Appl. No. 10/542,782

Reply to Office Action of March 6, 2006

Attorney Docket No. 26866U

ANNOTATED SHEET SHOWING CHANGES

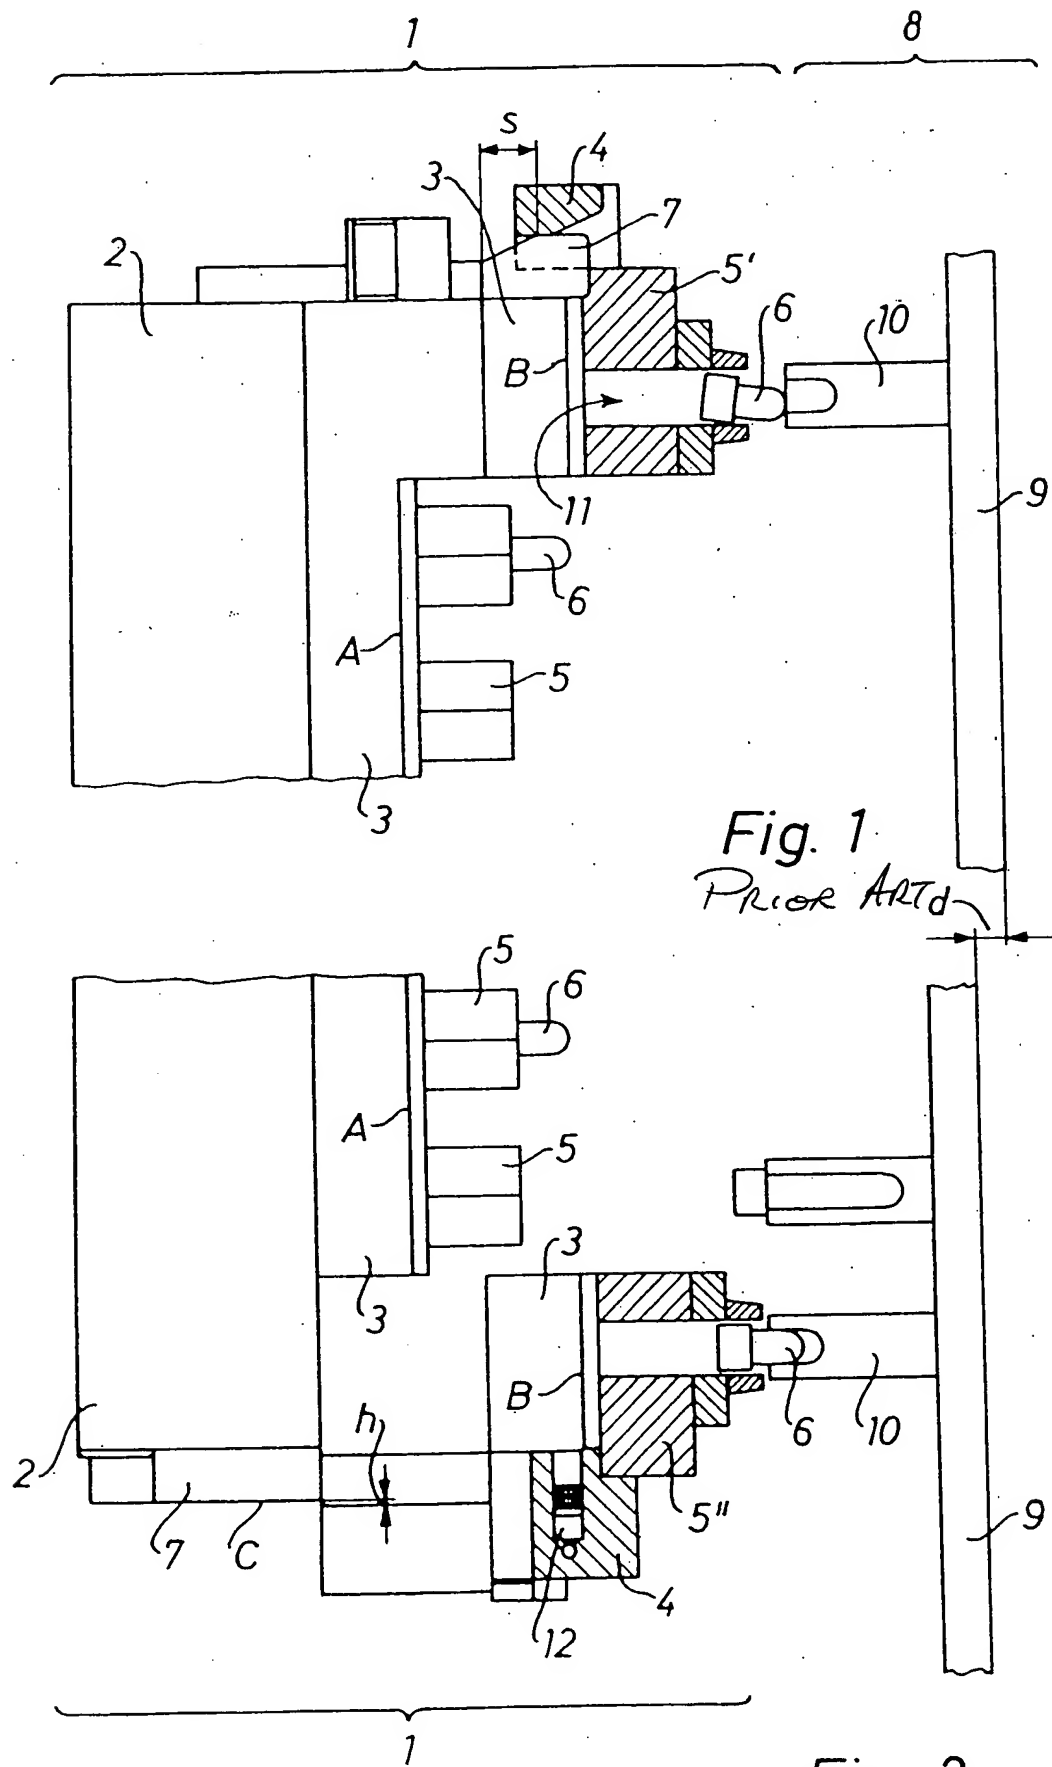
The Examiner objected to figure 1 for lacking a legend of –prior art–.

By this Response and Amendment, a replacement sheet of drawings, which identifies figure 1 as prior art, is included in the Appendix to this paper.
